Item 3.**Development Application: 117 Victoria Street, Potts Point - D/2024/524**

File No.: D/2024/524

Summary

Proposal Summary: The application seeks consent for demolition of the existing residential building and structures and construction of a new part-4 storey and part-8 storey residential flat building comprising 25 apartments (including 5 affordable housing units), 3 levels of basement for car parking, servicing and storage and a rooftop communal open space with pool.

Figure 30: Excerpt from applicant's SEE showing building elements which exceed the 15m height control

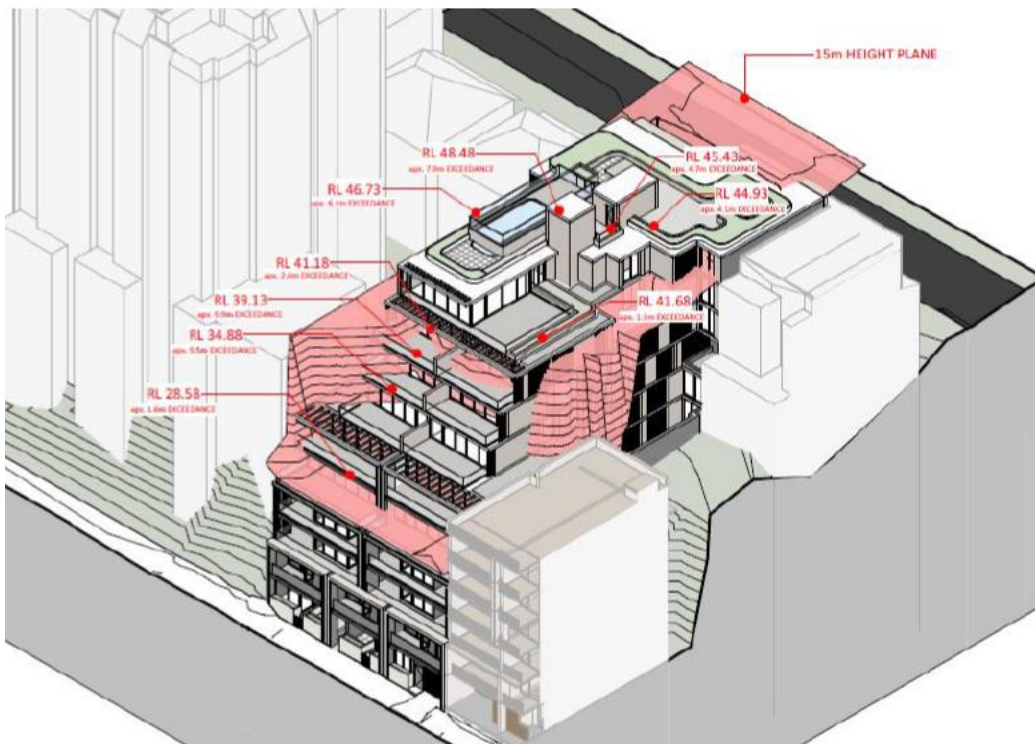
99. As discussed above, the proposed affordable housing component for the development does not equal at least 10% of the GFA of the building. The additional floor space and height under Chapter 2 Division 1, Clause 16 of the Housing SEPP therefore does not apply to the development, as per Clause 15C of the Housing SEPP.
100. The applicant states that the proposed development has a maximum height of 24.88m as measured from existing ground to the balustrades of the Level 08 private open space addressing Brougham Street. This is a variation of 9.88m or 65.8% to the Sydney LEP 2012 height development standard (and a 37% variation if the bonus height was available).
101. Height plane diagrams submitted by the applicant showing the proposed exceedances above the 15m height control and the projected 18.15m bonus height are shown below in Figures 30 and 31.

Figure 31: Excerpt from applicant's SEE showing building elements which exceed a projected 18.15m bonus height control (not currently available to the development as discussed above)

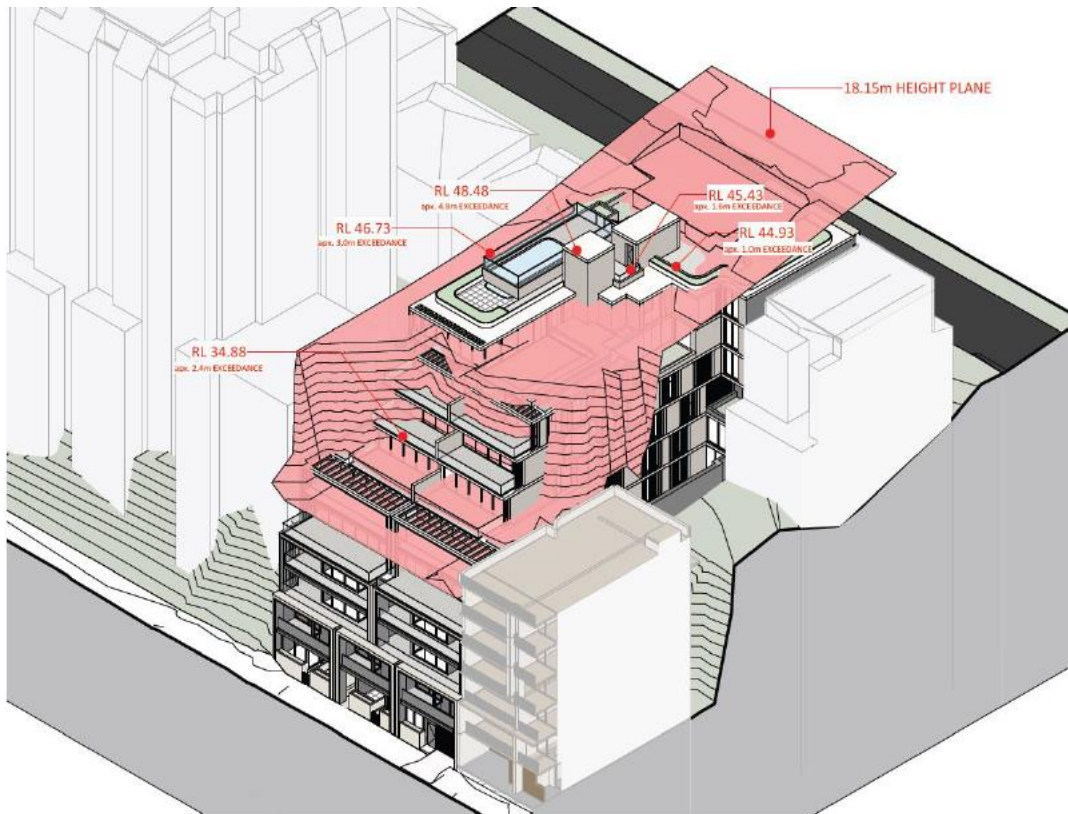
102. It is noted, however, that the 'existing ground' line depicted in submitted proposed sections does not appear to adequately describe the complex existing ground plane that is evidenced in the survey. Without this, the extent of the height breach cannot be accurately defined.

Figure 32: Excerpt of proposed southern elevation which shows building form which does not relate to the topography of the site (highlighted in yellow)

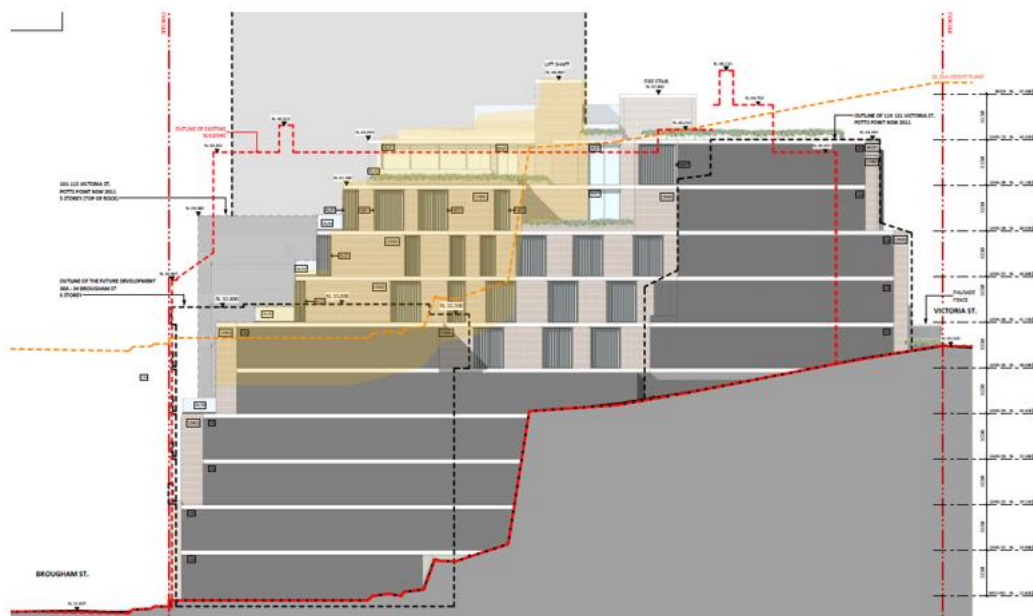
130. The proposed building does not relate to the stepped cross-sectional topography of the site (and the form of the height plane) and does not retain the taller portion of the building on the ridge as required by Section 2.4.3 of the Sydney DCP 2012. The unacceptable form is expressed in yellow in Figure 32 below.

Figure 33: Excerpt of proposed southern elevation which shows built to boundary sections of the proposed basement levels (highlighted in orange)

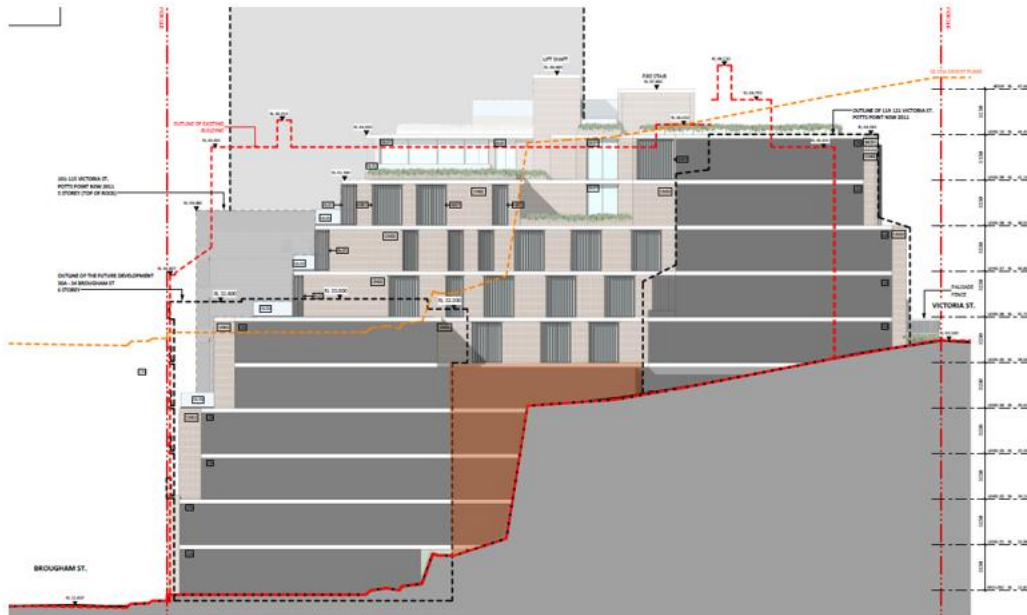
140. There is also insufficient detail relating to the impact of the proposed built to boundary basement walls, depicted in orange in Figure 33 below, on neighbouring properties.

141. These walls will have an overbearing impact on adjoining properties and do not comply with Objective 3J-4 of the ADG which states that protrusions of car parks should not exceed 1m above ground level.
142. Additionally, instead of being aligned with the predominant façade wall of the adjacent building at 119 to 121 Victoria Street, the proposed Victoria Street facade is aligned with the outermost extent of the parapet detailing of the neighbouring building which is not supported.
143. The proposed development fails to demonstrate adequate setbacks and building separation distances are provided between neighbouring sites, to achieve reasonable levels of amenity for neighbouring buildings. The development does not comply with the setback requirements of Section 4.2.2 of the Sydney DCP 2012 or objective 3F of the ADG and is not supported.

Figure 35: Excerpt from applicant's Arboricultural report which identifies existing trees likely to be impacted by the proposal

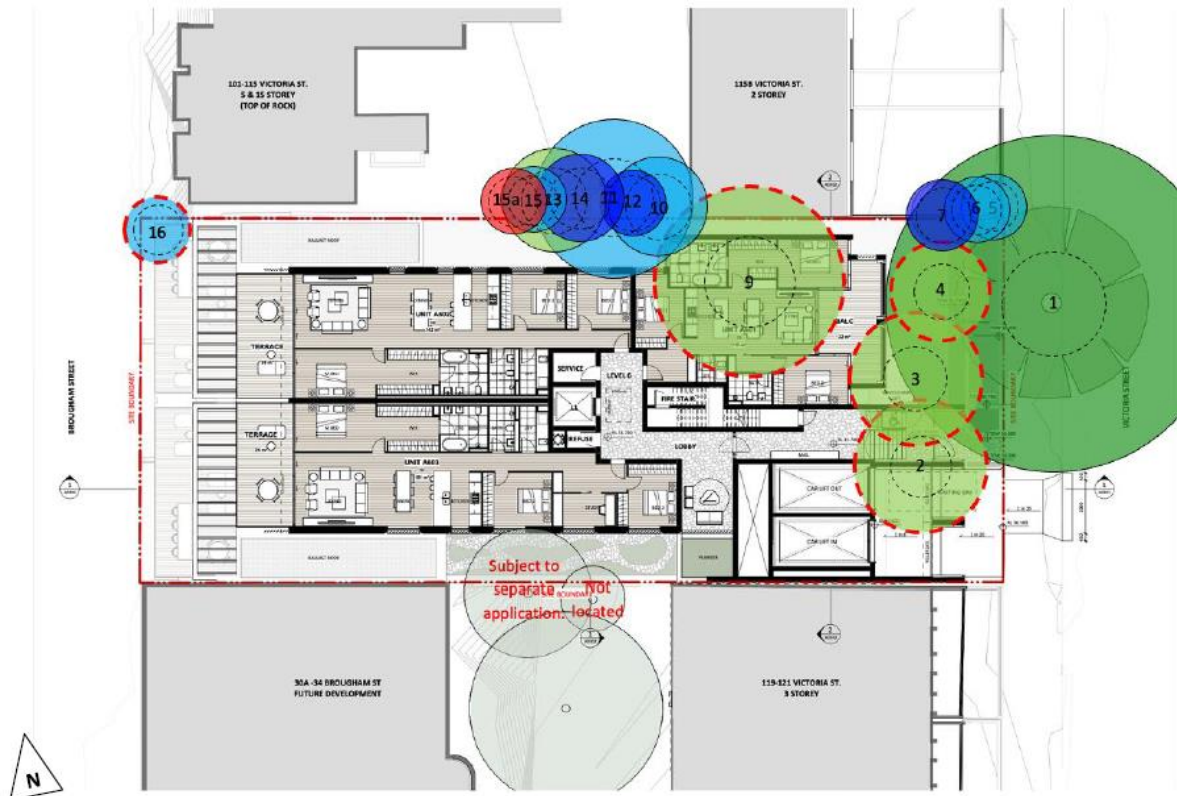
150. The objectives of Section 3.5.3 of the Sydney DCP 2012 state that development must ensure the protection of trees within and adjacent to development sites.
151. An Arboricultural Impact Assessment was submitted with the amended application. The report found that there were sixteen trees on the site and within the adjacent surroundings (neighbouring properties and public domain) that may be impacted by the proposed development (see Figure 35 below).

152. The City's Tree Management Specialist reviewed the amended architectural plans and the submitted Arboricultural report and advised that the proposal has not demonstrated that the requirements of Section 3.5.3 of the Sydney DCP 2012 are met due to the following:
